Subject: *Revised MLUP and Response to EPD Permit Coordination Comments 9.10.21
Twin Pines Minerals, LLC
Saunders Demonstration Mine
Charlton County, Georgia
EPD Mine ID No. 2073*

Summary of Revisions to Sheets 1 through 14 of the Revised MLUP

Response to EPD Comments

Figure 3 Mining Schedule

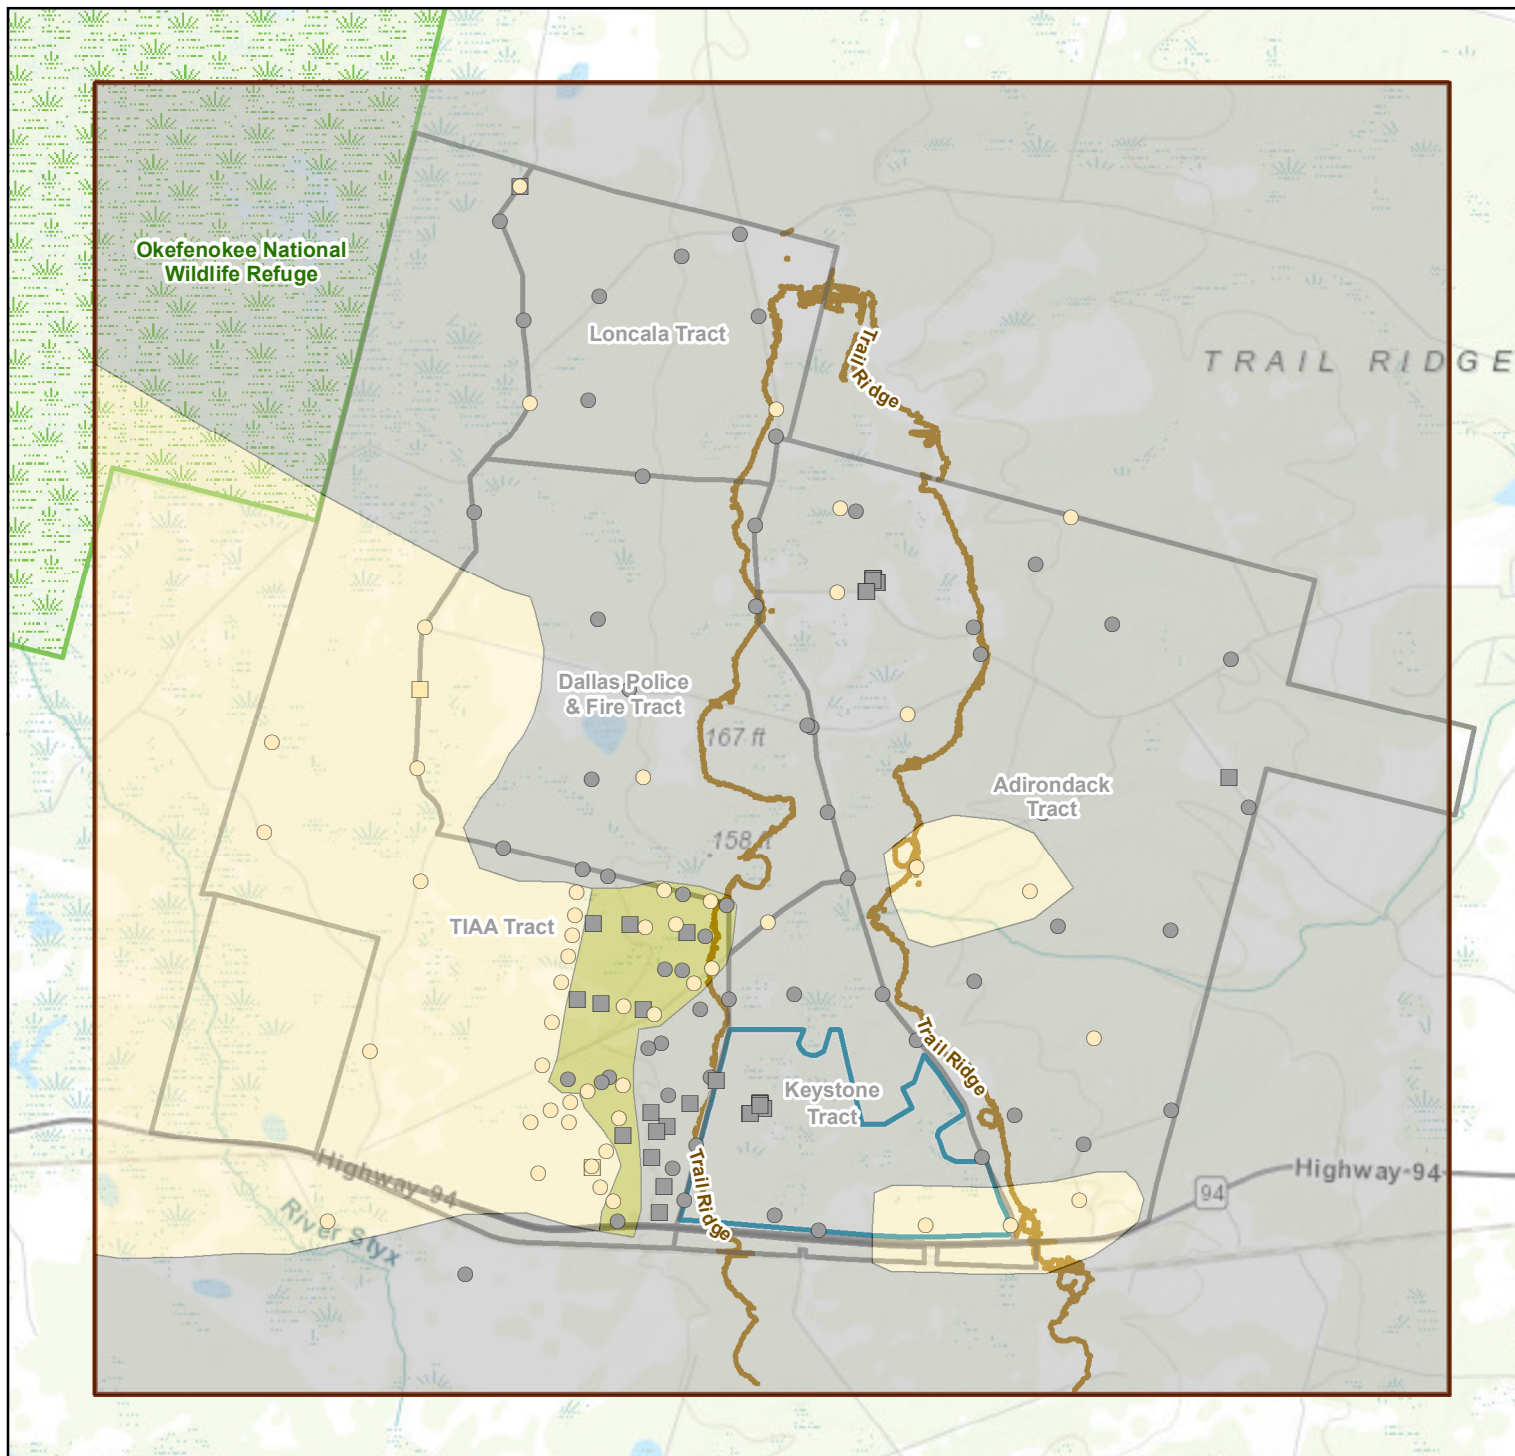
EPD Comment - Page 12: *Please say explicitly if the addition of bentonite was simulated in the mining area shown on Figure 3 (and later figures) or if it was simulated for the entire are (it was simulated in the mining area shown on Figure 3 but that needs to be clarified in the report).*

Response: The modeling report text has been updated as requested in Section 7.0 on Post-Mining Analysis section (page 12).
